# CONCEPT DESIGN STATEMENT

## NGAKAWAU RESTORATION PROJECT – OCEAN OUTFALL COMPONENT

3 July 2008

## Additional information in response to Section 92 Request

Photograph 1

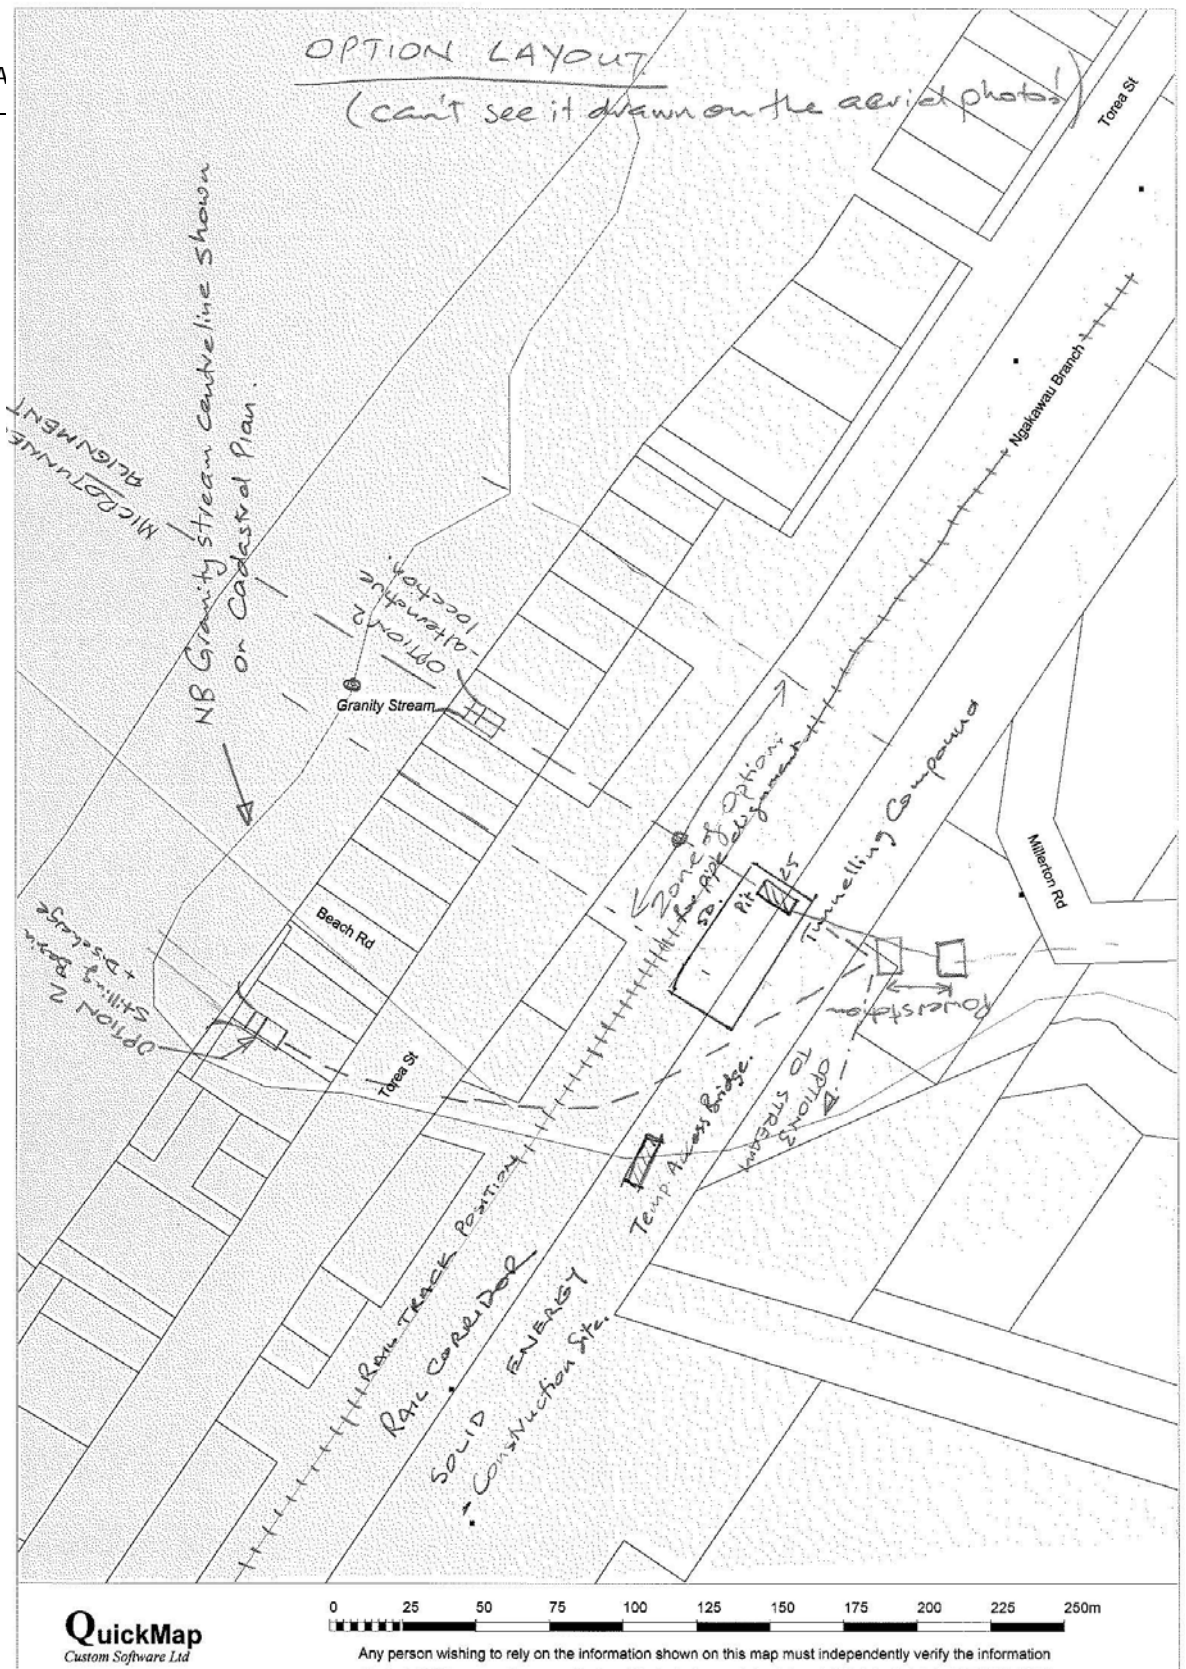
While it is suggested in the HDL preliminary proposal that the tailwater from the power station would be conveyed parallel and adjacent to Granity Stream, before being piped to sea, microtunnelling lends itself to direct (and indeed only straight line) conveyance from below the power station site to sea. The outfall construction site viewed at the time of the site visit, an area seaward of the highway and immediately north of the Granity Stream bridge, is not well suited to microtunnel construction as it is of limited size and not convenient for the delivery and storage of tunnelling materials. A more suitable area for a temporary construction site below the power house on Solid Energy owned land and the vacant side of the rail corridor would allow the crossing of the rail, the highway, and tunnelling to an offshore discharge location in a single operation. While land ownership above the alignment seaward of the highway is an issue, it is suggested that in the scale of the project this could be easily overcome with several options of alignment location available. This option would ensure that adequate construction area is available with more opportunity to keep construction access, noise etc further from numerous dwellings. Possible sites are roughly sketched on a cadastral plan attached (Sketch 1), and a photo showing a typical microtunnel construction site with the sheet piled access pit in the foreground is appended (Photograph 1).

Sketch 1 – Possible Site Location and Layout

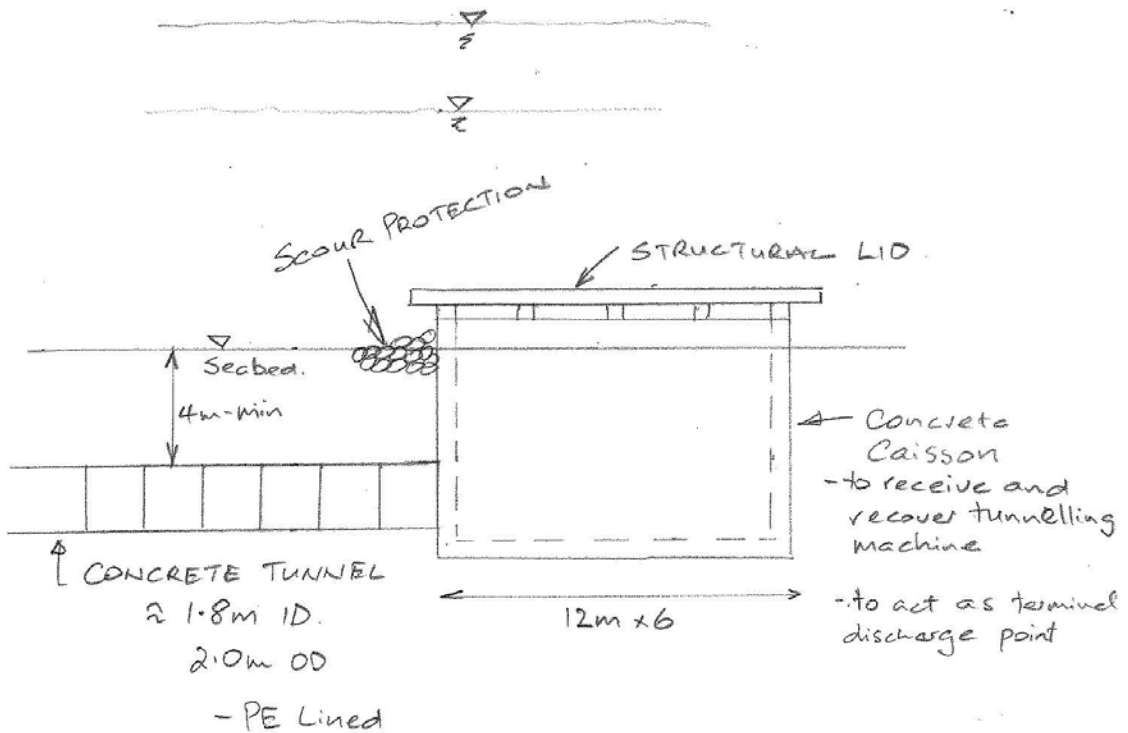
These issues were considered as part of our input to the URS report to Solid Energy on Stockton Mine Water to Ocean where we concluded that a practical solution to outfall construction in this area required microtunnelling of the nearshore section. For your project the same conditions apply. Microtunnelling (which would need to be affirmed as feasible in terms of detailed geology/soil conditions but applicable in sands as suggested to exist) has been shown to be successful for single drives of 800 to 1000 m providing the option to traverse the surf zone. A discharge location a minimum of 800 m offshore is recommended to reduce storm exposure and ensure reasonable access for inspection and maintenance of the terminal structure.

Sketch 2 - Schematic section of Outfall Terminal Discharge

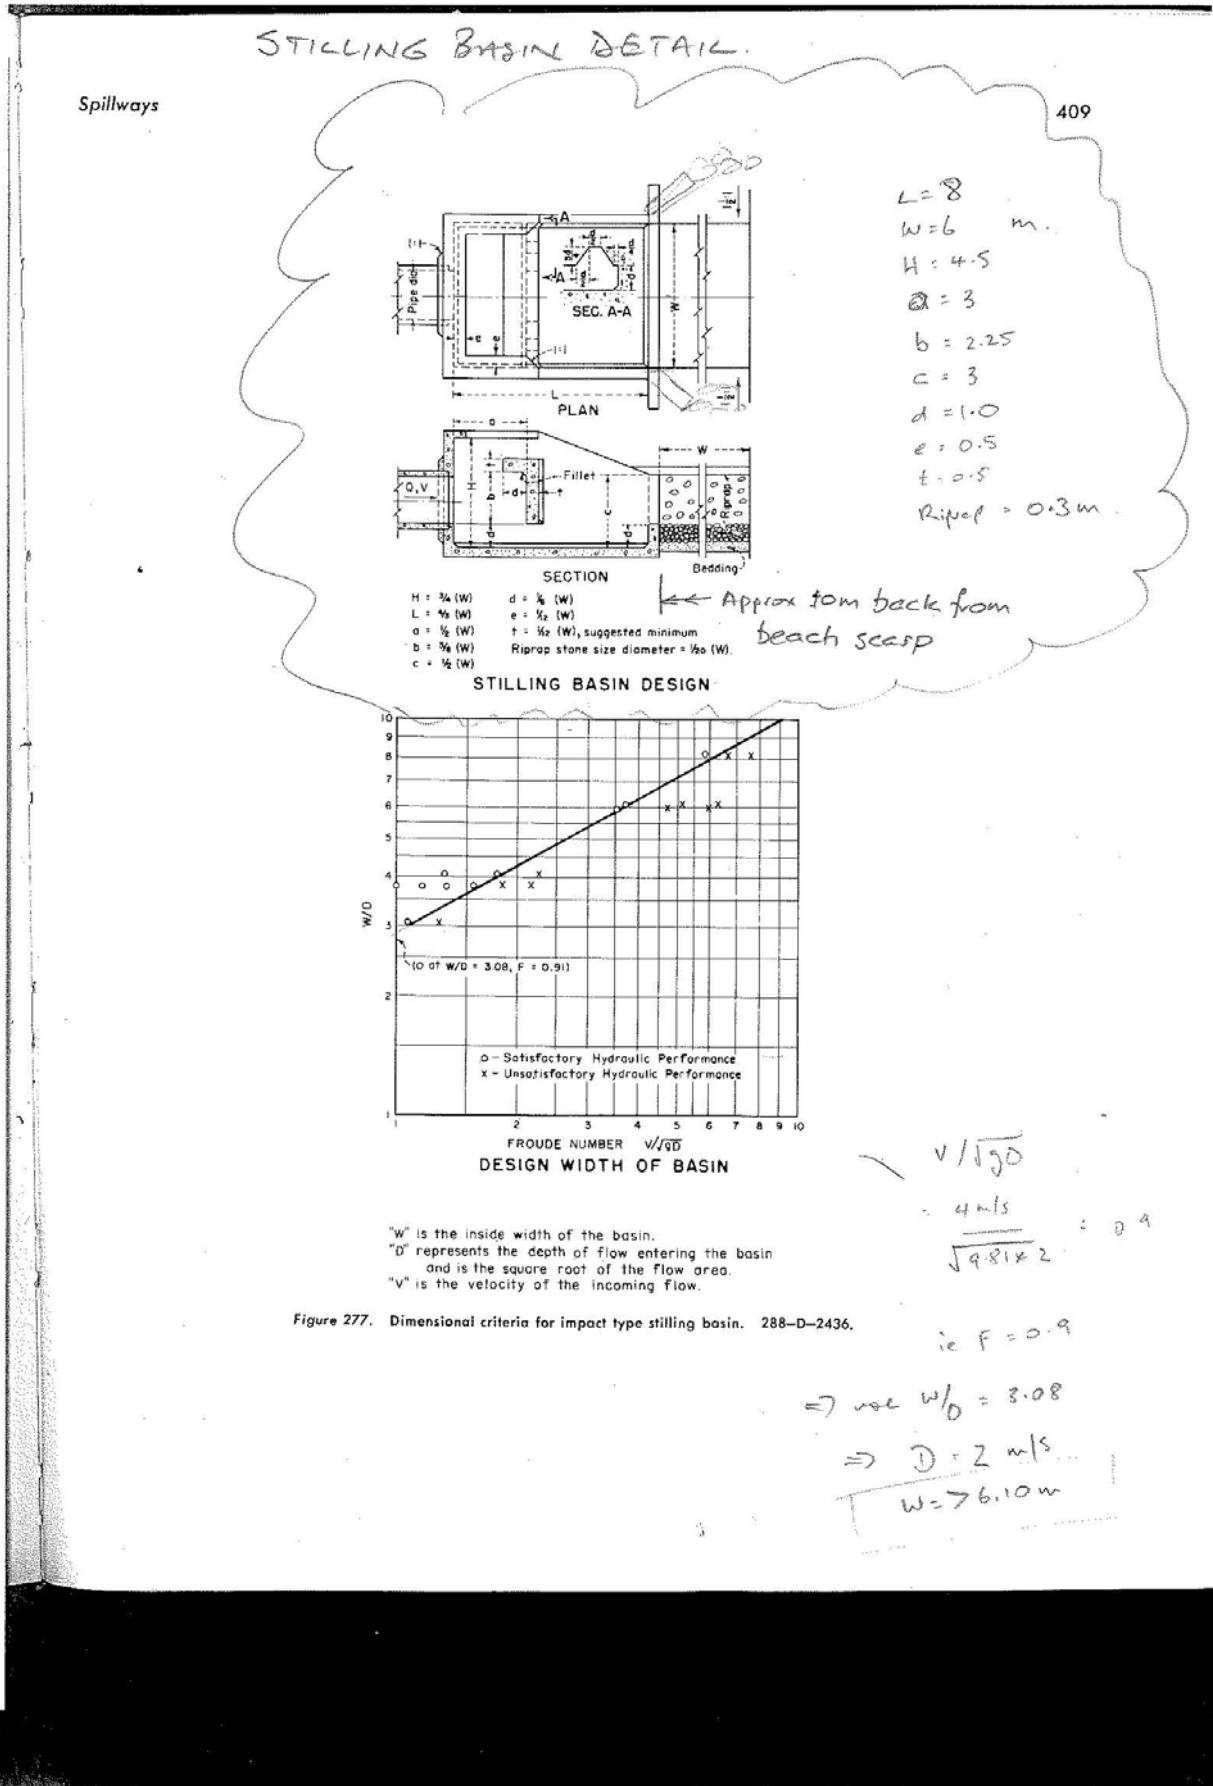
At the seaward end of the microtunnel some 800 m offshore a substantial riser would be required to convey the discharge from the tunnel which would require about 4.5 m cover to the seabed above it. This could comprise a concrete caisson structure with rock scour protection to ensure stability in storm conditions. One option would be to install and backfill such a caisson, and drive the tunnel into it allowing the tunnelling machine to be recovered without having to expose the end of the segmental tunnel structure in a large excavation (Sketch 2). The need for particular dilution performance at this location has not been defined with a point discharge considered adequate in the meantime.
